# Cider Mill Heights

Ellington, Connecticut

REPORT

ENVIRONMENTAL REVIEW TEAM REPORT  
ON  
CIDER MILL HEIGHTS CONDOMINIUMS  
ELLINGTON, CONNECTICUT

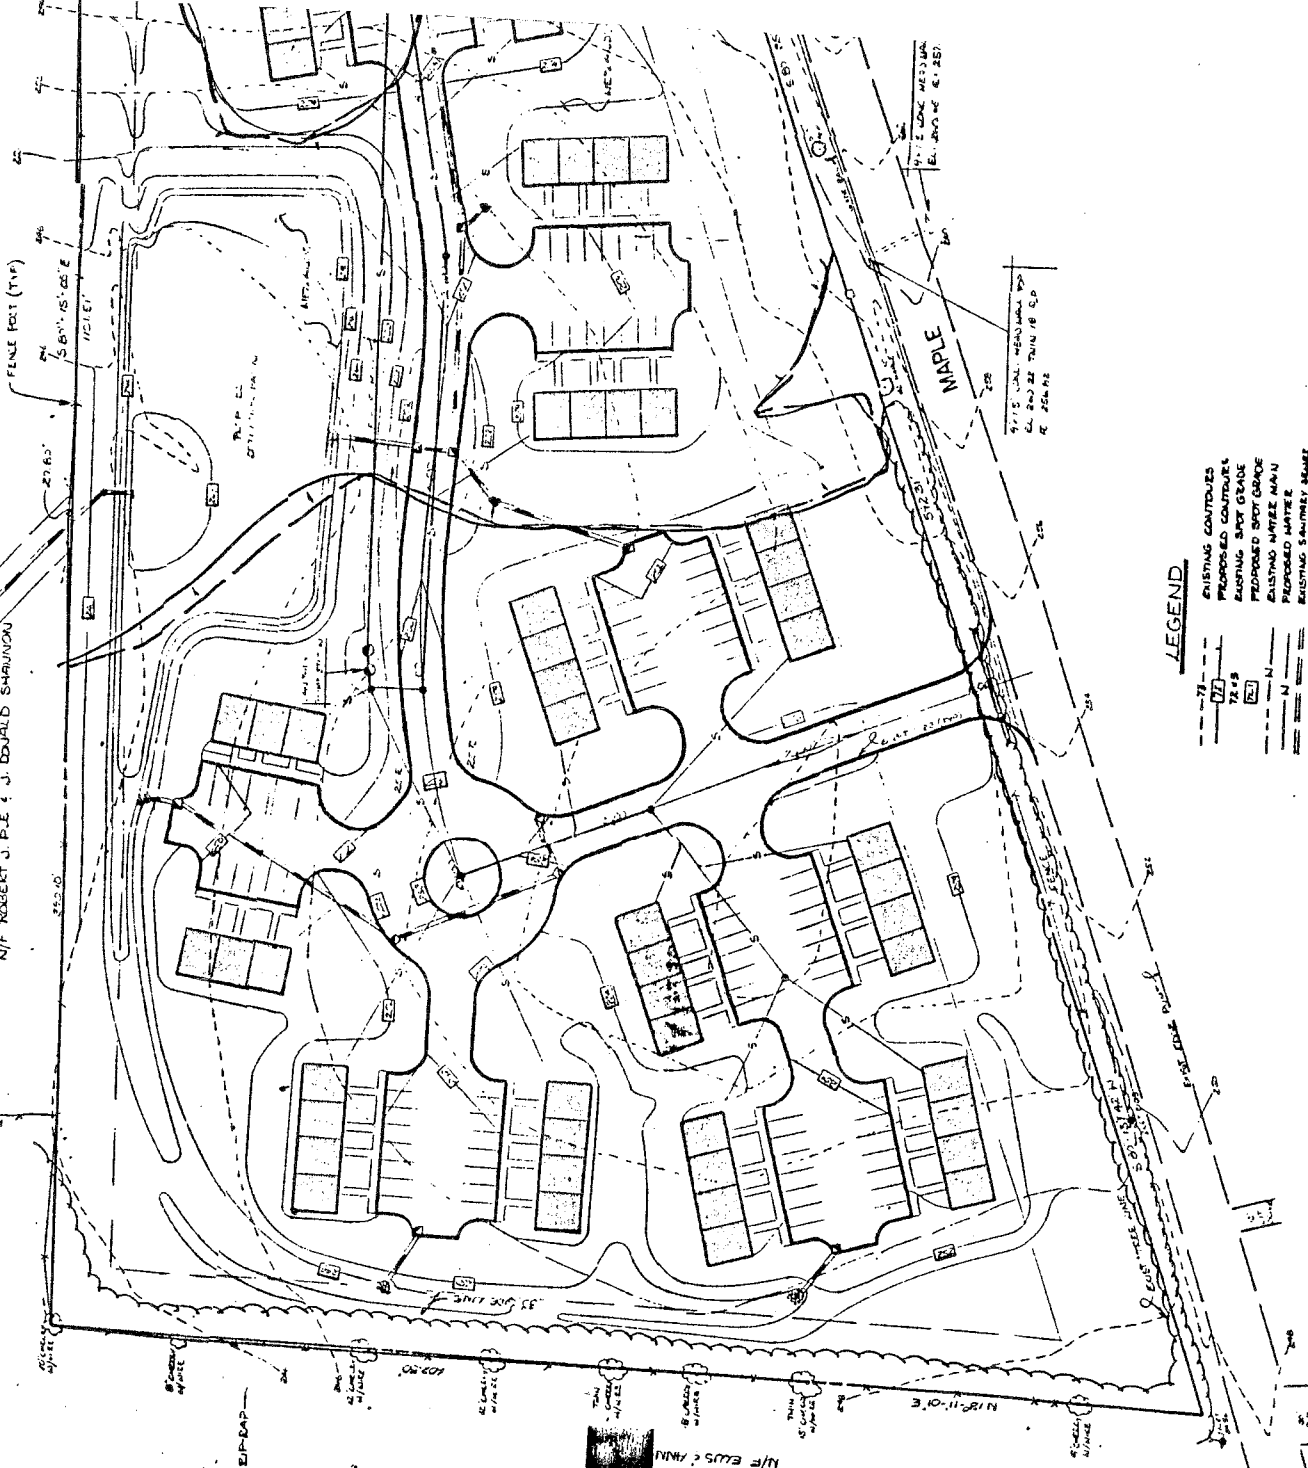
DURING THE DISCUSSION WITH TOWN OFFICIALS, AND ERT MEMBERS, THE PROPERTY OWNER INDICATED WILLINGNESS TO REMOVE THE THREE (3) CONDOMINIUM UNITS FROM THE WETLAND. THE REMOVAL OF THE CONDOMINIUM UNITS FROM THE WETLAND AREA WOULD BE A WISE MOVE AND WOULD DECREASE THE VOLUME OF THE BASIN.

THE DETENTION BASIN PROPOSED HAS AN EXCAVATION BELOW NATURAL GROUND OF ABOUT THREE (3) FEET, WITH AN OUTLET PIPE EXTENDING ABOUT 300 FEET ACROSS ANOTHER PROPERTY. THIS ALLOWS THE DETENTION BASIN TO BE COMPLETELY DRAINED AFTER EACH STORM. THE OTHER ALTERNATIVE IS TO KEEP THE OUTLET PIPE ABOVE GROUND AND BUILD A DIKE TO CONTAIN THE STORM RUNOFF. THIS MEANS KEEPING THE ROAD, PARKING, AND HOUSING ABOVE THE HIGH WATER LINE DURING STORM RUNOFF EVENTS.

THE WETLAND SOIL IS A RAYPOL SILT LOAM AND WOULD ALLOW VERY SMALL AMOUNTS OF WATER RECHARGE UNLESS THE DETENTION BASIN WAS EXCAVATED BELOW TWENTY-FOUR (24) INCHES TO INTERCEPT THE DEEP SANDS AND GRAVELS.

THE DETENTION BASIN CALCULATIONS WERE CALCULATED USING THE UNIVERSAL RATIONAL HYDROGRAPH METHOD. THIS METHOD IS NOT WRITTEN IN ANY TEXTBOOKS THAT THE TEAM ENGINEER IS FAMILIAR WITH, AND IS NOT LISTED AS A VALID METHOD IN THE GUIDELINES FOR SOIL EROSION AND SEDIMENT CONTROL FOR CONNECTICUT.

1) THE SITE CONTAINS INLAND WETLANDS THAT WILL REQUIRE FILL OR EXCAVATION TO FACILITATE THE CONSTRUCTION OF THREE (3) CONDOMINIUM UNITS, A ROADWAY CROSSING, AND THE PROPOSED DETENTION BASIN AND OUTLET. ONE POSSIBLE ALTERNATIVE TO LOCATING THE ROADWAY THROUGH THE CENTER OF THE WETLANDS WOULD BE TO CONSTRUCT THE ROADWAY AS PART OF THE DETENTION BASIN DIKE.

3) THE SITE PLAN SHOULD STATE THE NAME OF THE SOIL SCIENTIST WHO FLAGGED THE WETLANDS AND THE DATE IT WAS DONE. THE SOIL SCIENTIST SHOULD ALSO CERTIFY THAT THE WETLAND BOUNDARIES AS THEY APPEAR ON THE SITE PLAN ARE SUBSTANTIALLY CORRECT BY SIGNING THE SITE PLAN.

--THE REGULATED INLAND WETLANDS WITHIN THE SITE HOLD LOW POTENTIAL FOR BUILDING PURPOSES. IT IS RECOMMENDED THAT NO BUILDINGS BE PLACED IN THIS AREA.

--ANOTHER ALTERNATIVE TO THE PROPOSED DETENTION BASIN IS TO KEEP THE OUTLET PIPE ABOVE GROUND AND BUILD A DIKE TO CONTAIN THE STORM RUNOFF.

--ONE POSSIBLE ALTERNATIVE TO LOCATING THE PROPOSED ROADWAY THROUGH THE CENTER OF THE WETLANDS WOULD BE CONSTRUCT THE ROAD AS PART OF THE DETENTION BASIN DIKE.

--THE SITE PLAN SHOULD STATE THE NAME OF THE SOIL SCIENTIST WHO FLAGGED THE WETLANDS, AND HE/SHE SHOULD CERTIFY THAT THE BOUNDARIES OF THE WETLANDS AS THEY APPEAR ON THE SITE PLAN ARE SUBSTANTIALLY CORRECT.
